HISTORIC PRESERVATION BOARD STAFF REPORT

98 NW 5th Avenue

Meeting	File No.	Application Type
October 7, 2020	2019-261	Class III Site Plan & Certificate of Appropriateness

FRONTAGE STANDARDS, MINIMUM STREETSCAPE WIDTH

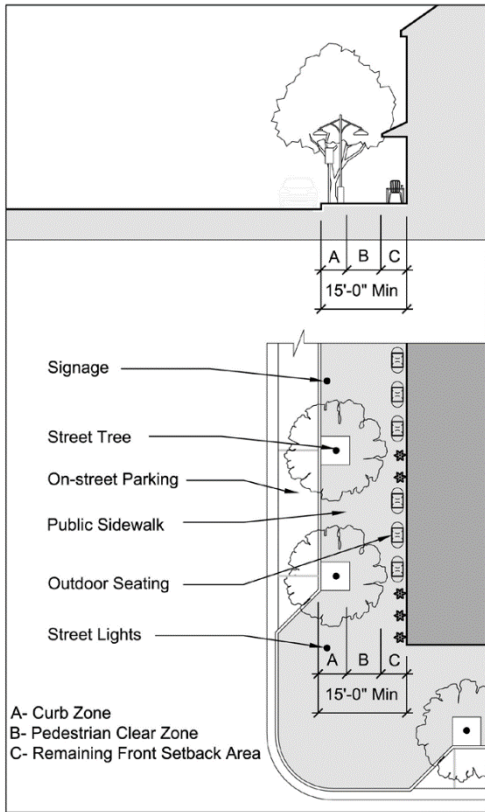
Streetscape Standards	Minimum Standard	Proposed
A- Curb Zone	4'-0"	4' (east) 7' (north)
B- Pedestrian Zone	6'-0"	6' (east) 6' (north)
C- Remaining Front Setback Area	5'-0"	4'8" (east) 1'6" (north)
Total Streetscape Width	15'-0"	14'8" (east) 14'6" (north)

The subject property has frontage along NW 5th Avenue (east side) and NW 1st Street (north side). There is a five-foot right-of-way dedication required along NW 5th Avenue and a 1'6" alley right-of-way dedication required along the north/south alley in the rear of the property. On the north side of the property, a 10' easement is proposed along NW 1st Street. While the site plan indicates that the requirements of the code can be met as there is sufficient space to accommodate the required streetscape, the dimensions are incorrectly illustrated on plan sheet AS-102 as 7' is dimensioned rather than 4' along NW 1st Street. An added condition of approval is that the site plan be updated to correctly illustrate the required 4' Curb Zone along NW 1st Street.

1. That the plan sheet AS-102 and any associated plan sheets be updated to correctly illustrate the required 4' Curb Zone along NW 1st Street.
2. That street trees be located within the Curb Zone of the adjacent NW 1st Street right-of-way;
